SUBJECT: Environmental Assessment Addendum and Finding of No Significant Impact

Addendum to Environmental Assessment to Authorize an Increase to the ROW Width to Accommodate a Utility Corridor to the Axe 148-94-11A-1H, Vise 148-94-1A-2H TF, Poblano 148-94-02D-1H, and Cayenne 148-94-02D-2H TF Well Pad

**Addendum to Environmental Assessment to Authorize an Increase to the ROW Width
to Accommodate a Utility Corridor to the Axe 148-94-11A-1H, Vise 148-94-11A-2H TF,
Poblano 148-94-02D-1H, and Cayenne 148-94-02D-2H TF Well Pad**

November 2011

Figure 1. Axe 148-94-11A-1H, Vise 148-94-11A-2H TF, Poblano 148-94-02D-1H, and Cayenne 148-94-02D-2H TF well pad and access road/utility corridor location.

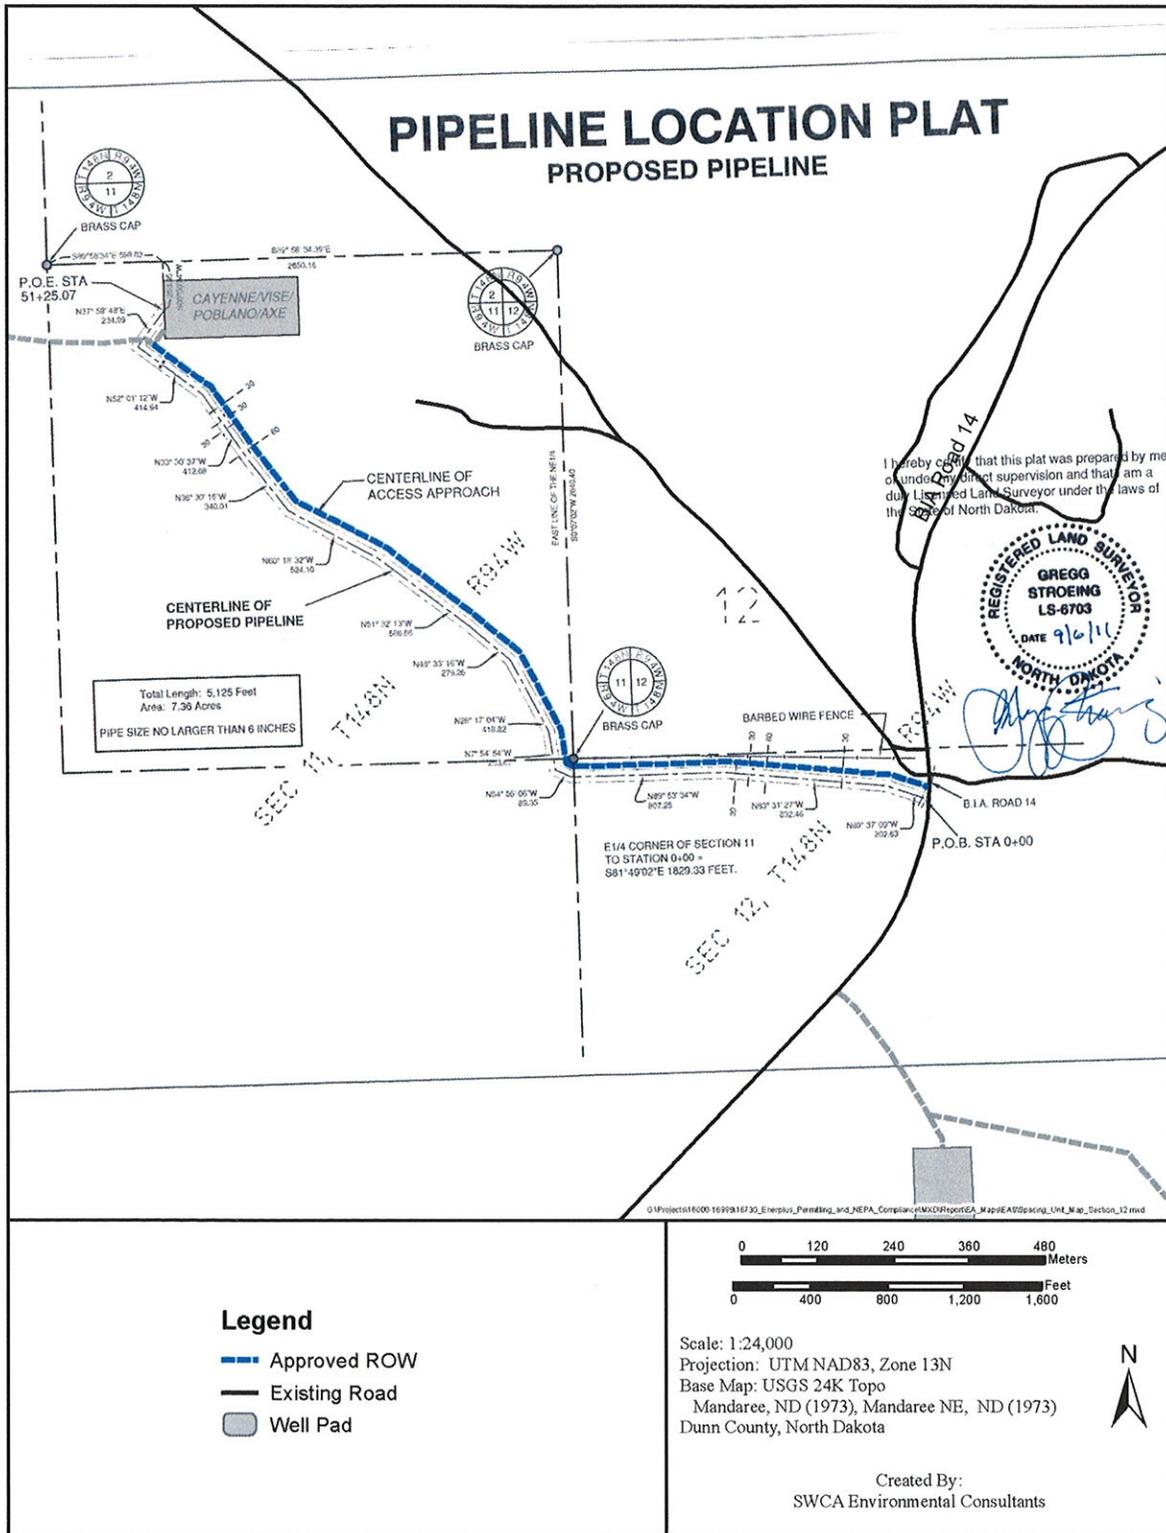
The purpose of the proposed action is to authorize Enerplus to expand the width of the approved 5,016-foot right-of-way (ROW) from 60 feet to 90 feet to allow for construction of the road and utility corridor, to include the gathering pipelines (one gas pipeline and one water pipeline, neither of which would exceed a diameter of 12 inches), an electric line, and a fiber optic line. The proposed gathering pipeline system would transport gas and produced water from productive wells to markets and disposal facilities. If warranted, a buried electrical line may be installed in the future within the currently proposed ROW. A radio tower would also be installed on the location to allow for remote communications between the Enerplus Denver office and the well pad.

The proposed access road/utility corridor would travel northwest approximately 5,016 feet to the turn-off to the well pad. Initially, disturbance was calculated on a 60-foot ROW width (7.12 acres of disturbance) for new access road construction, without a utility corridor, that would originate off of BIA Road 14. The access road/utility corridor from the well pad to the main access road between the Axe/Vise/Poblano/Cayenne pad and a second pad to the west

was analyzed on a 100-foot ROW in the environmental assessment. Approximately 3.5 acres of additional disturbance would occur as a result of the ROW being expanded to 90 feet, bringing the adjusted total access road/utility corridor disturbance to 10.6 acres.
